DRAINAGE REPORT FOR KERRY'S CAR CARE SHEA

Plan #	
Case #	10-UP-2019
Q-S #	
<input type="checkbox"/> Accepted	
<input checked="" type="checkbox"/> Correction	
GA	10/21/2019
Reviewed By	Date

10-UP-2019
09/26/2019

grading and drainage plan

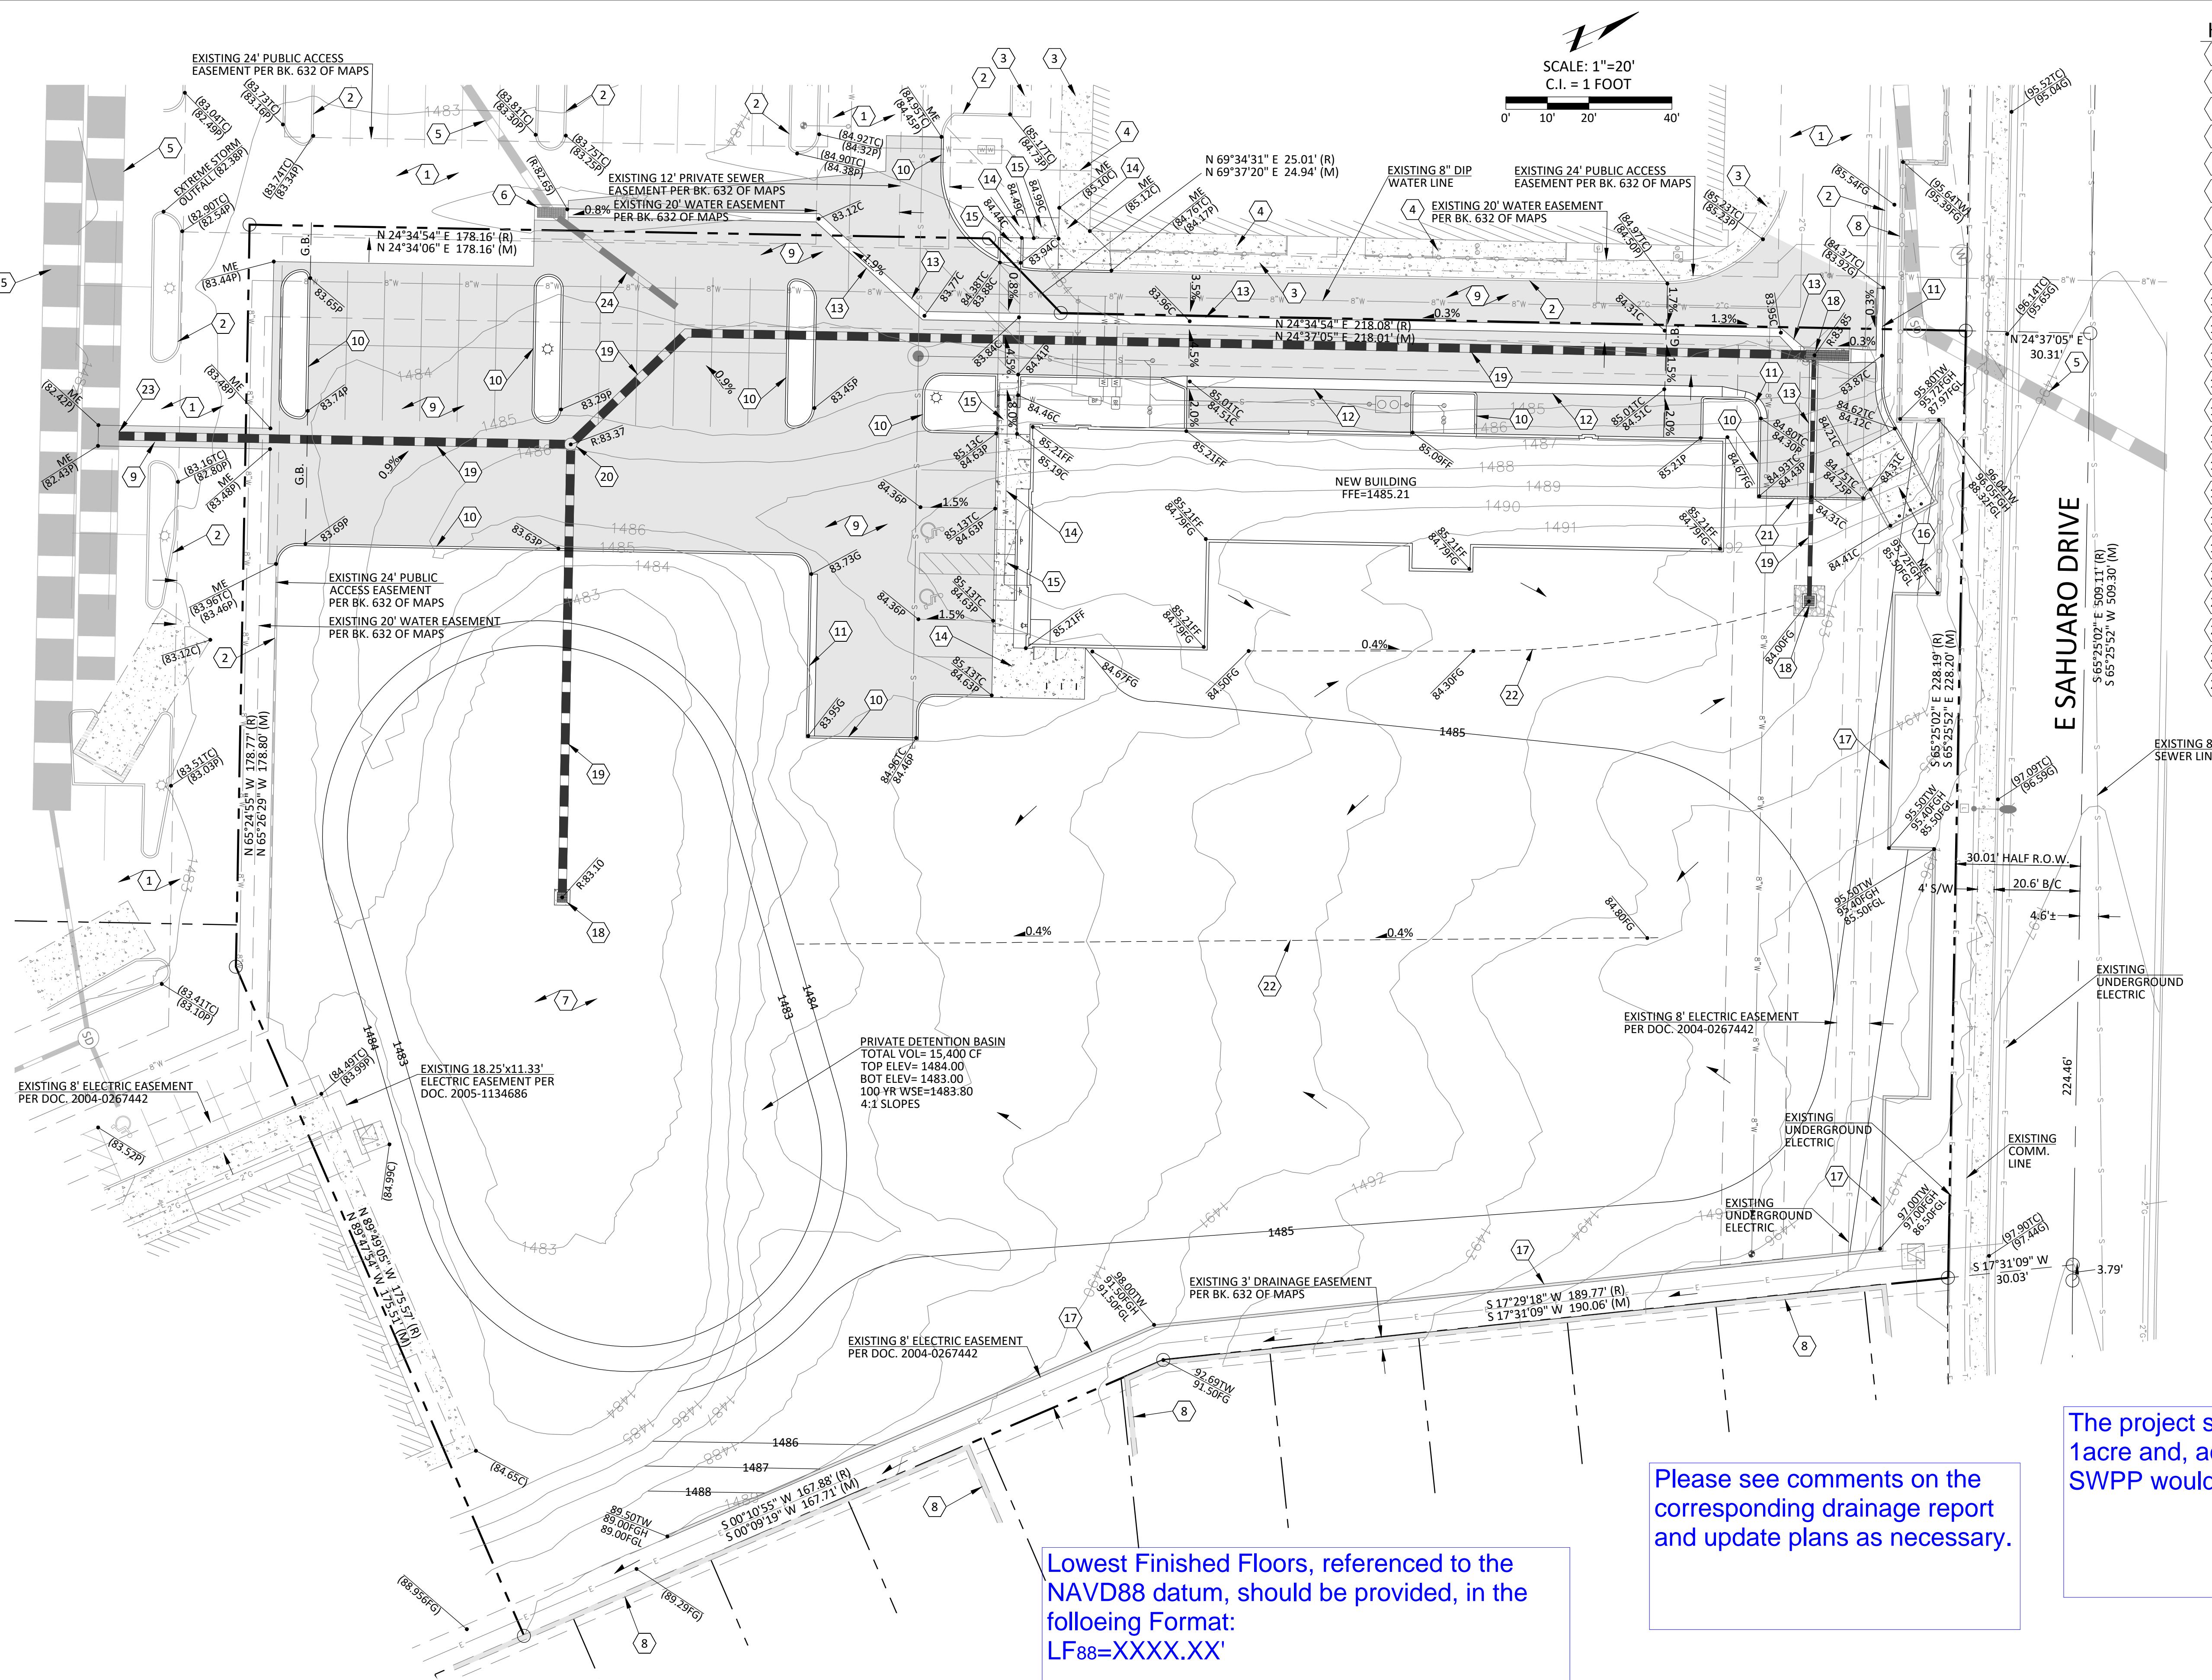
Please review all notes per comments on these plans and the corresponding drainage report and update as necessary
